A G E N D A

Architectural Review Board

October 27, 2020 – 5:30 p.m.

3A

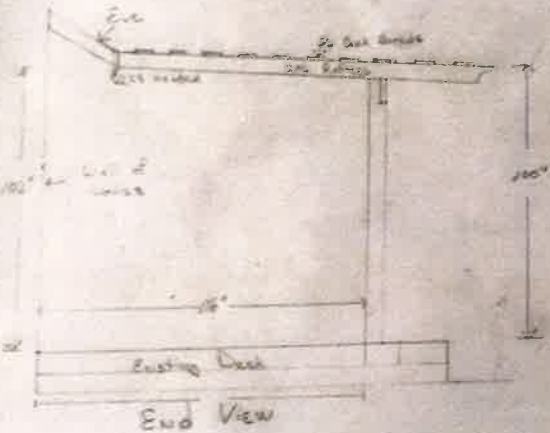
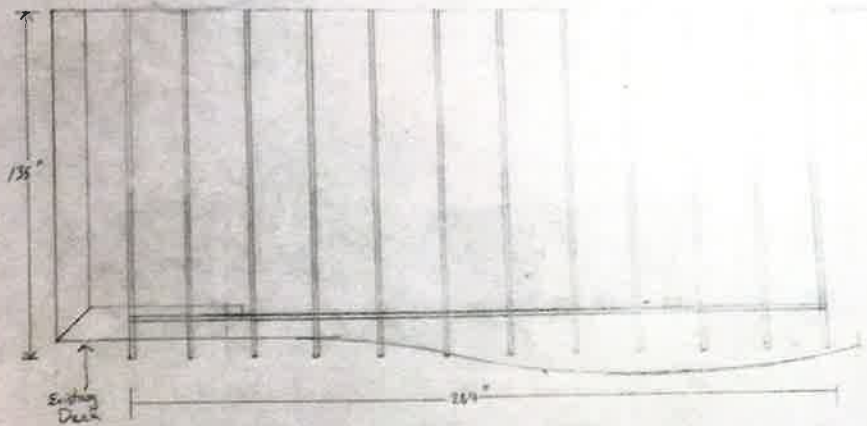
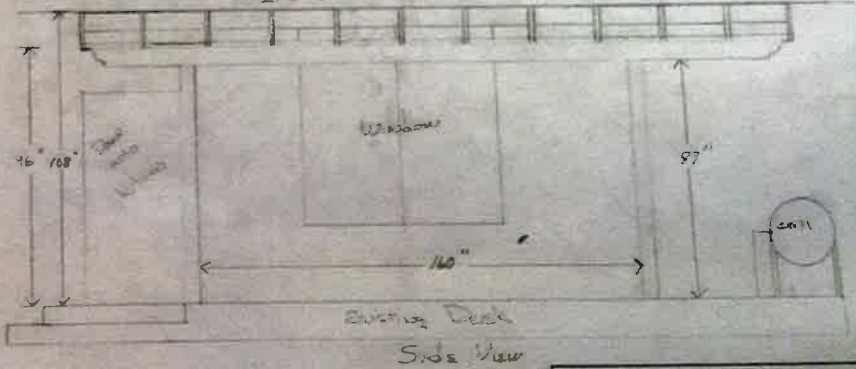
- This is a project that would be easily reversible with minimal impacts on the historic structure. No objection.

367 Cloverdale Road

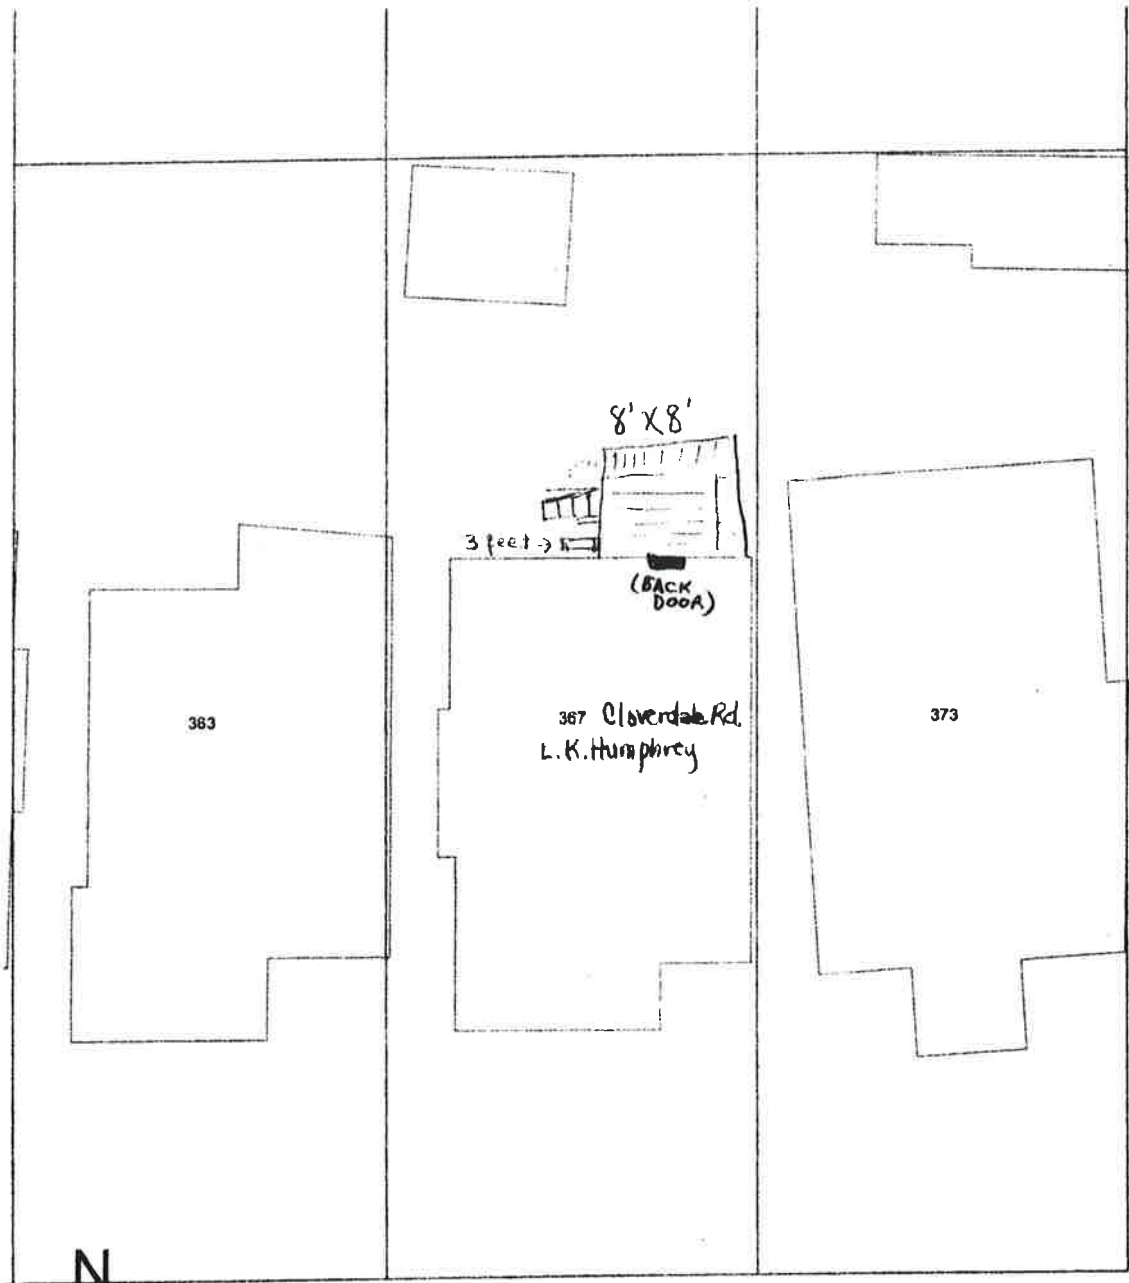
- The Board has routinely approved decks for what they are—modern outdoor conveniences—and this will not be visible from the street. It should also make using the back door a bit safer than the current steps. No objection.

KNOWLES RESIDENCE
PROPOSED SCREENED PORCH

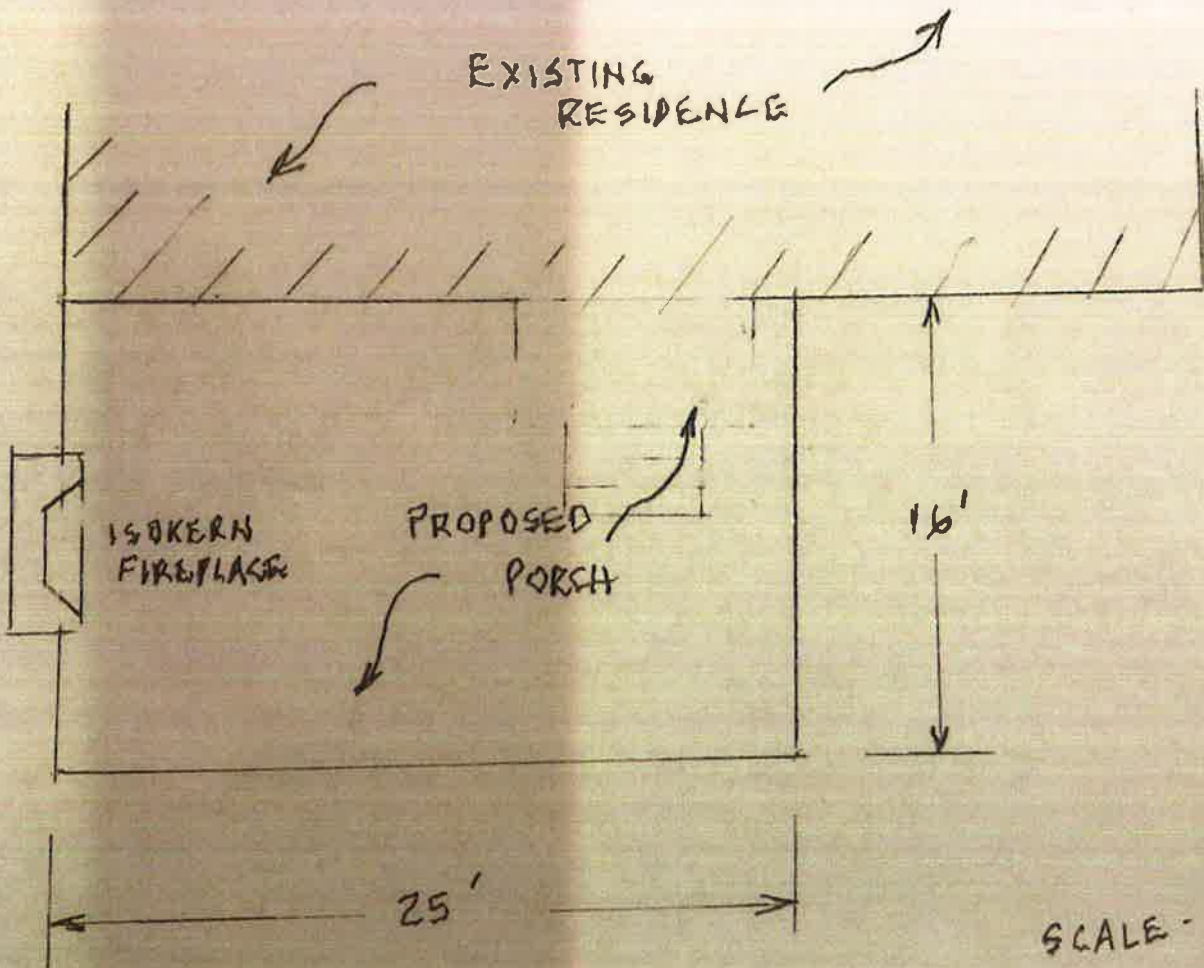
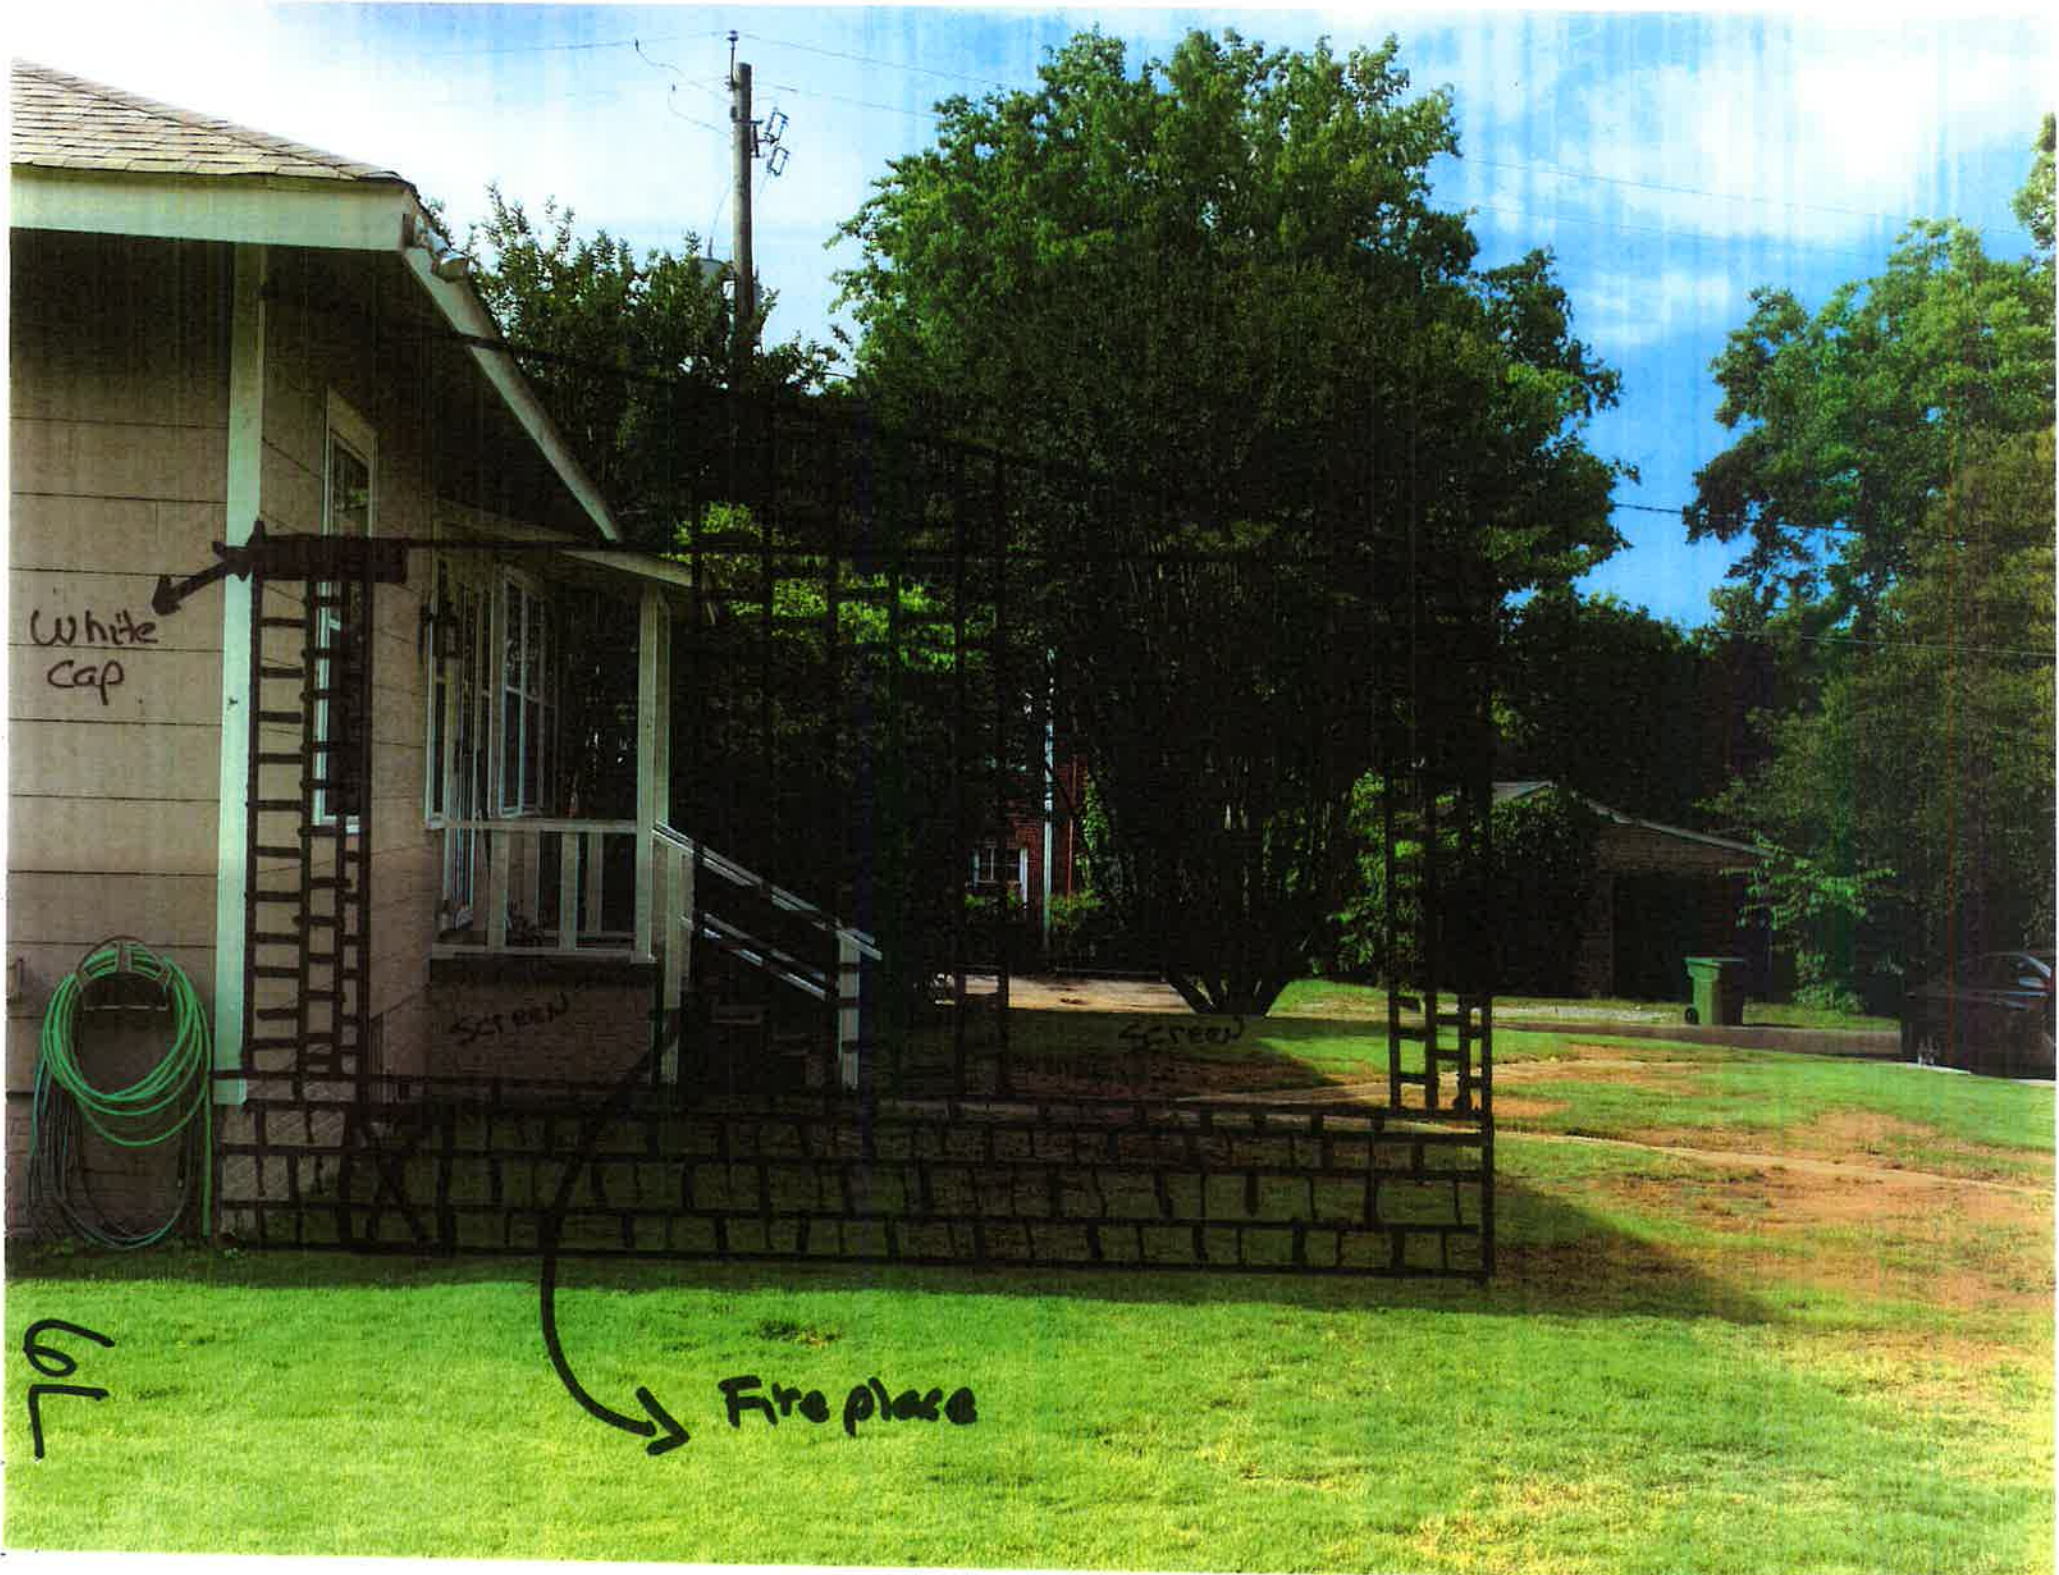
- This will be minimally visible from Cloverdale Road but more visible from Coleman.
- As the porch will attach to and not tie into the structure, it is another addition that would be easily reversible with minimal impact to the historic structure. No objection.

Picture #5: View of left side of house and privacy fence:

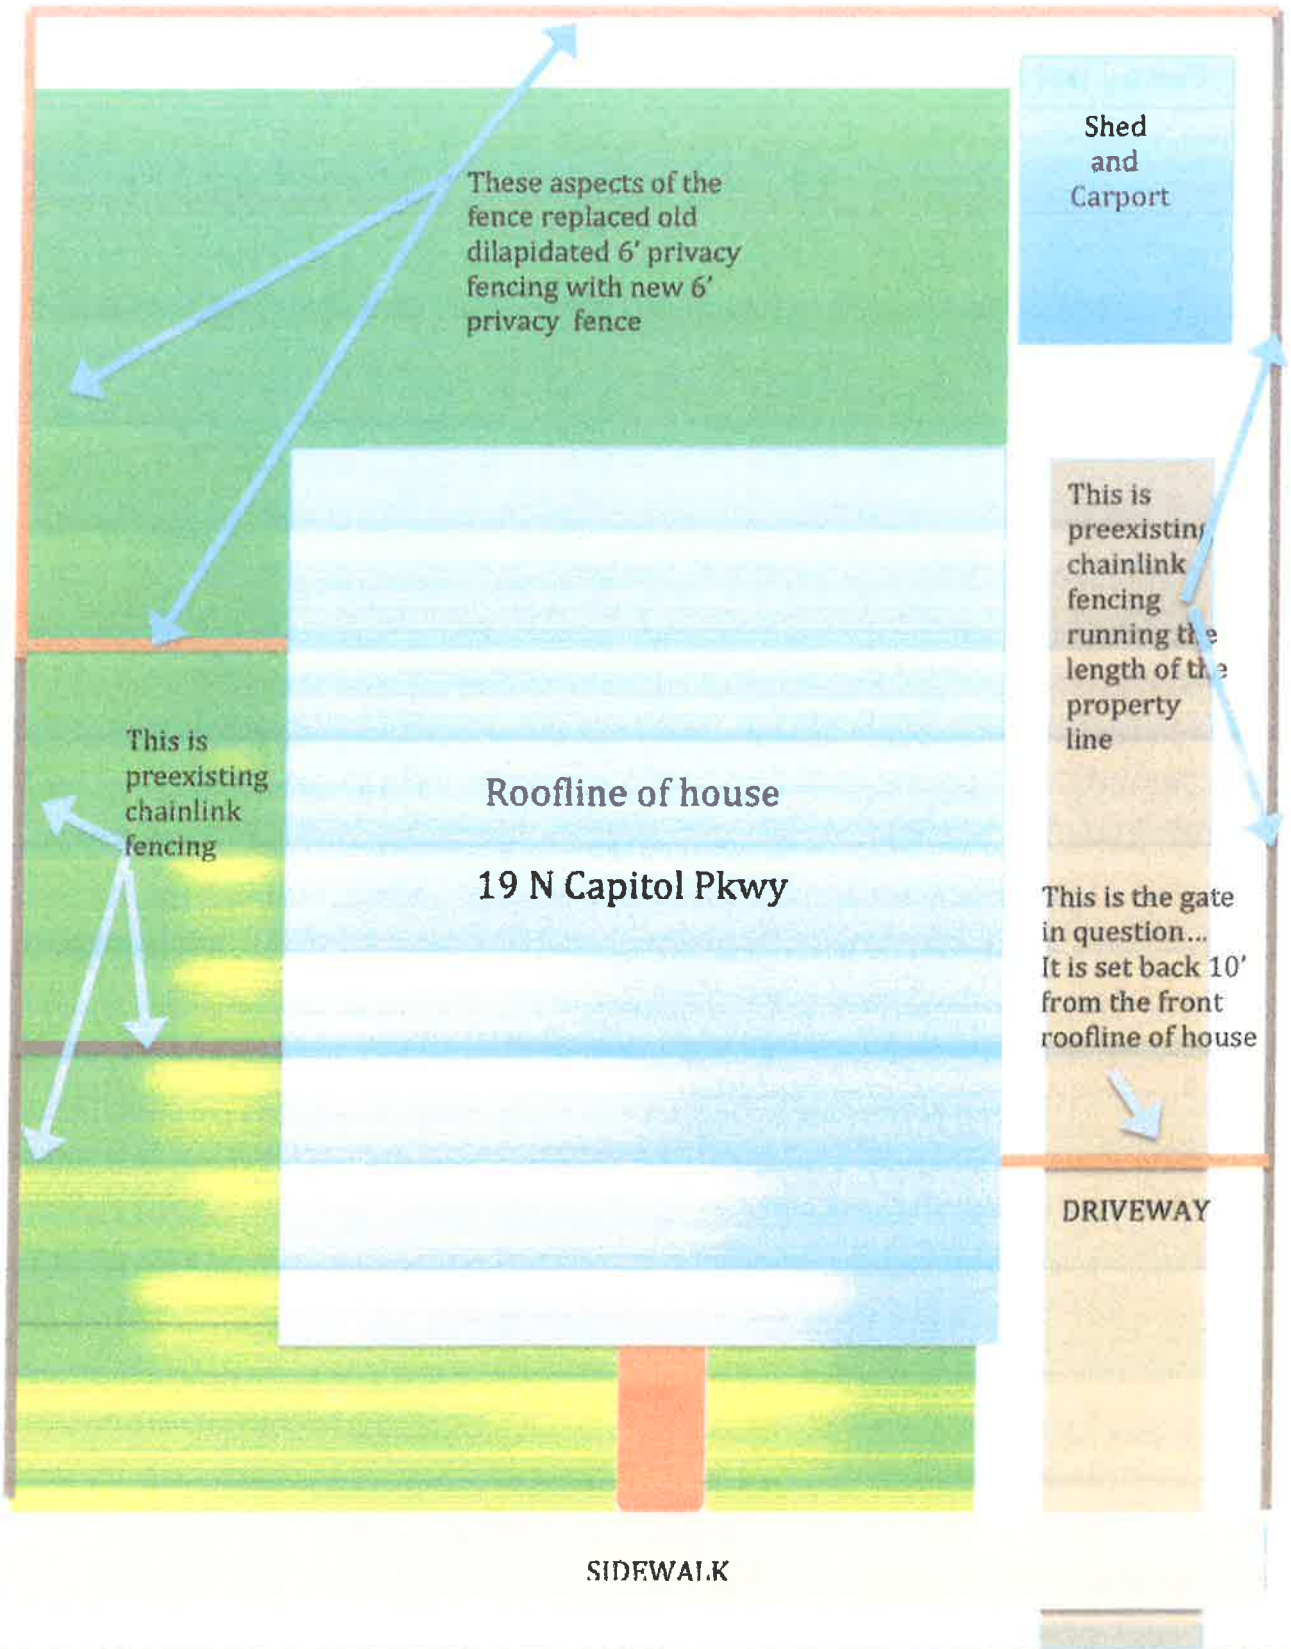
- Again this is a recently purchased property, across the street from a property fronting Madison Avenue (same listing agent) that also came before this board in violation due to actions taken before closing.
- A building permit was not obtained but is required for privacy fences by the Building Department, a copy of a letter sent to the vendor/installer is also attached.
- Generally rear yard fences are not problematic, but the Board has asked fences and gates be set back from the front corners of houses. The Board may consider the circumstances and could stipulate when the gate fails it needs to be placed further back. Such a stipulation could be recorded with the deed.

9A

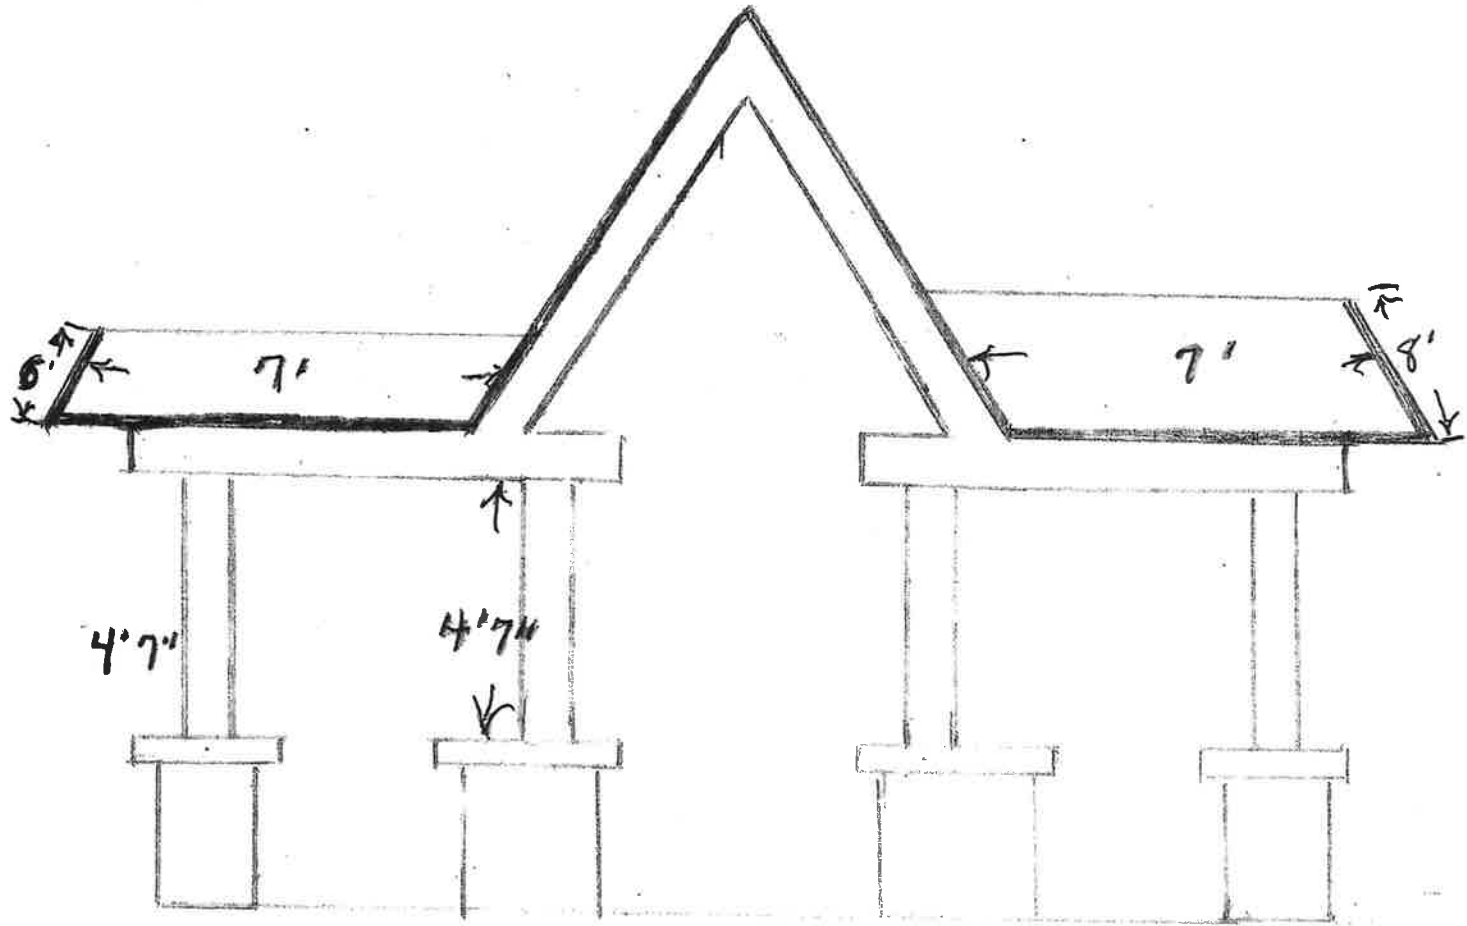
- Staff is working with the petitioner to impose the drawing onto the house so we can see visually where it lines up, particularly in respect to the half timbering in the gable.
